COMMITTEE OF ADJUSTMENT

MINOR VARIANCE REPORT

APPLICATION: CAV A/046/2024 RELATED FILE: N/A

CAV A/046/2024 - 1260 Cleaver Drive (East District) (OP Designation: Low Density Residential)

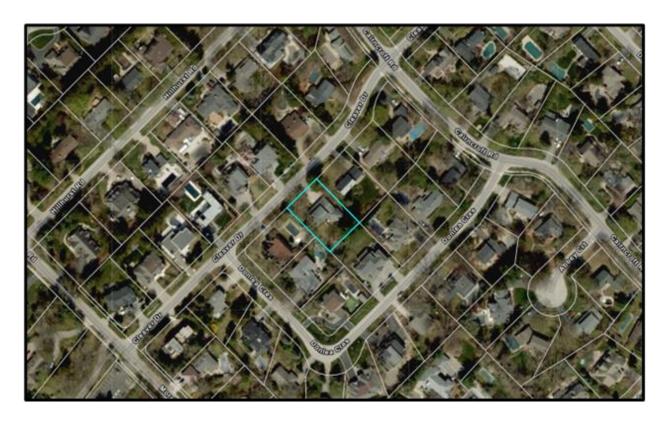
The applicant proposes to construct a two-storey detached dwelling, subject to the variances listed above.

The intent of the Official Plan is to protect the existing character of stable residential neighbourhoods. While redevelopment of some of the original housing stock has taken place in the surrounding area, Staff are of the opinion that the proposed dwelling would not implement the Design Guidelines for Stable Residential Communities, nor maintain and protect the existing neighbourhood character. The proposed dwelling presents as substantially larger than adjacent dwellings and creates an overpowering effect on the streetscape. The overall increase in height being requested, along with the large two-storey front porch element also contributes to the overall scale and massing impacts of the proposed development. While there have measures taken to mitigate some of the potential impacts; such that the second storey roofline has been lowered just above the garage and at the far western portion of the dwelling, the remainder of the proposed dwelling still appears as a full two-storeys from the public realm. Furthermore, the

addition of dormer windows into the roof makes the dwelling appear to be 3-storeys in height directly above the front entrance area. The existing 2-storey home, and the proposed two-storey dwelling are compared in following images:

In Staff's opinion, the proposed height and overall design of the dwelling have not been properly considered when examining it against the existing character of the stable residential neighbourhood it is located in. As such, the proposal results in a development that appears to

On this basis, it is Staff's opinion that the variance #3 does not maintain the general intent and purpose of the Official Plan as this variance contributes to a proposal that would not maintain nor protect the character of the existing neighbourhood. Variances #1 and #2 however, do maintain the intent and purpose of the Official Plan. The increase in garage floor area has been added towards the interior of the dwelling, so that it still presents as a 2-car garage from the street and is not a prominent feature of the dwelling. While the increase in dwelling depth does not create any adverse shadowing, privacy, or massing impacts on adjacent dwellings from the rear yard and still allows for ample private amenity space.

The intent of the Zoning By-law provision regulating height is to reduce the potential for any adverse impacts on neighbouring properties such as shadowing, and to ensure the dwelling does not become an overpowering or predominant feature of the existing streetscape. The combination of the two-storey front porch element, third storey dormer windows, and 0.78 m increase in height, cumulatively contribute to enhancing the massing and scale of the dwelling, resulting in an overbuild of the subject property. In addition, the proposed floor plans include two open-to-below areas that push the second storey floor area to the perimeter of the dwelling, making the dwelling appear larger. While open-to-below areas do not count towards residential floor area, they do contribute to the overall massing and scale of the dwelling in a manner that is not compatible with the neighbourhood character. Additionally, there have been no other height variances approved in the immediate area at the magnitude as the one currently proposed. The increase in building height would not maintain the general intent and purpose of the Zoning Bylaw and negatively contributes to a mass and scale that is not in keeping with the existing neighbourhood.

Staff are of the opinion that the variance proposed for maximum height does not represent the appropriate development of the subject property as the variance is not minor in nature. The proposed dwelling creates negative impacts on the public realm in terms of massing and scale,

Staff object to variance #3 on the basis that it does not satisfy the four tests under the *Planning Act*. Further, it is Staff's opinion that variances #1 and #2 satisfy all four tests under the *Planning Act*. Should the Committee's evaluation of the application differ from Staff, the Committee should determine whether approval of the proposed variances would result in a development that is appropriate for the site.
